<b>AMENDMENT OF SOLICITATION/MODIFICATION OF CONTRACT</b>				1. CONTRACT ID CODE	PAGE <b>1</b>	OF PAGES <b>3</b>
2. AMENDMENT/MODIFICATION NO. <div style="text-align: center;">A004</div>		3. EFFECTIVE DATE <div style="text-align: center;">07/20/12</div>		4. REQUISITION/PURCHASE REQ. NO. <div style="text-align: center;">AC-12-03931</div>		5. PROJECT NO. <i>(If applicable)</i>

**SUBJECT:** Addendum No. One to the Specifications and Drawings for replacement of Instrument Landing System (ILS) for runway 13R at Houma-Terrebonne Airport in Houma, LA.

**Clarification to Question and Answer #15 on Addendum #1.**

STEEL CHANNEL MEZZANINE  
TYPICAL STAIR & LANDING

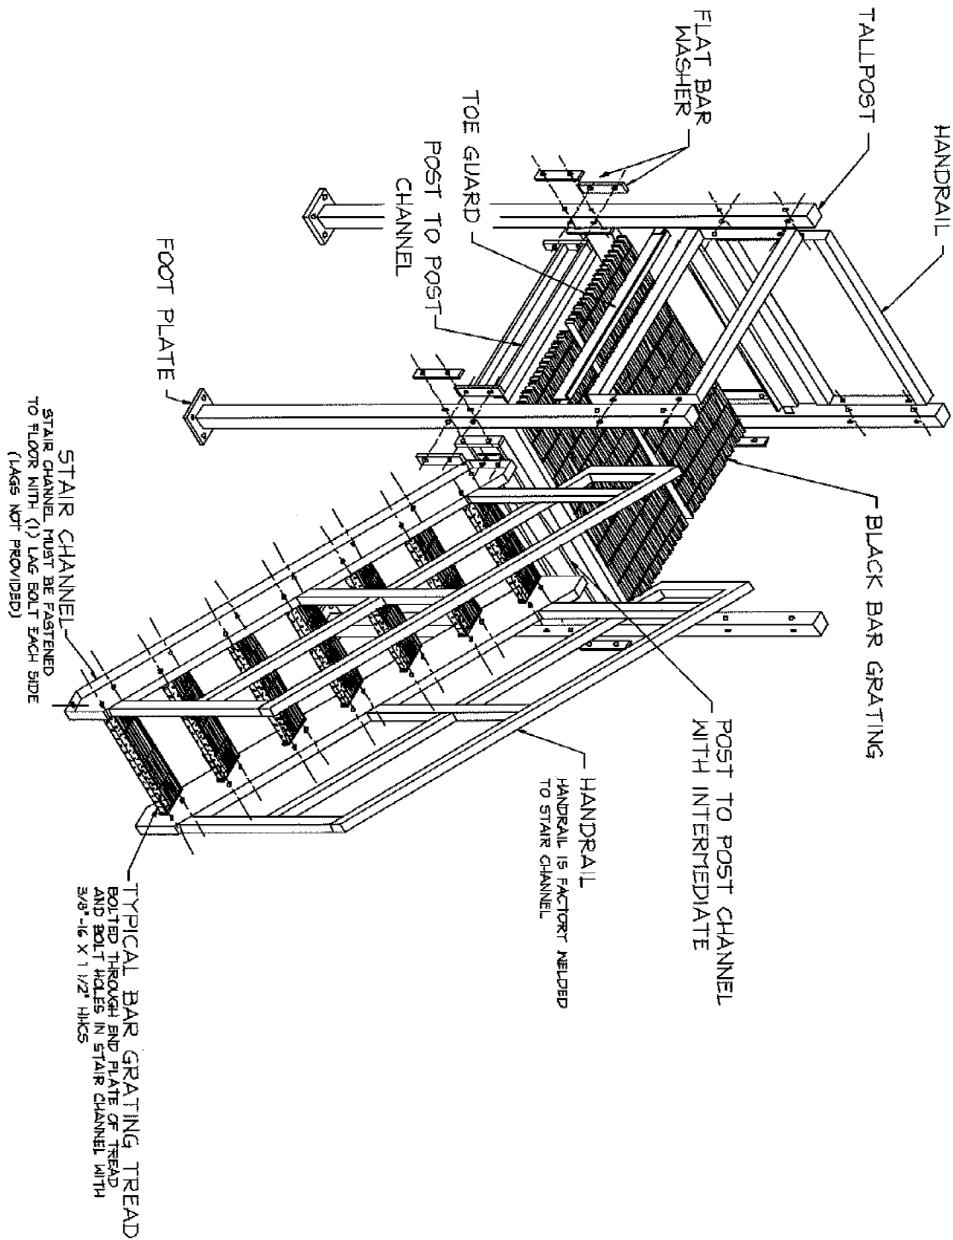
**15. LOC S001 – Detail 3 indicates concrete steps & detail 8 indicates fiberglass steps. Please clarify.**

Please use the following specs for the steps and its landing, steel construction (Drawing HUM-D-LOC18-S001 note #8).

- 1) Both steps and landing confirm to OSHA.
- 2) Overall height from the top of the landing is 49".
- 3) The landing is straight thru.
- 4) The finishing is duplex system with any available color.
- 5) Use FS Industries- PO Box 72659, 50 Sprague Street, Providence, RI 02907. Toll free: 1-800-421-0314 In RI: 401-421-0314 , Fax: 401-421-5679, [www.fsindustries.com](http://www.fsindustries.com). (See attached FS Industries typical stair and landing sheet).
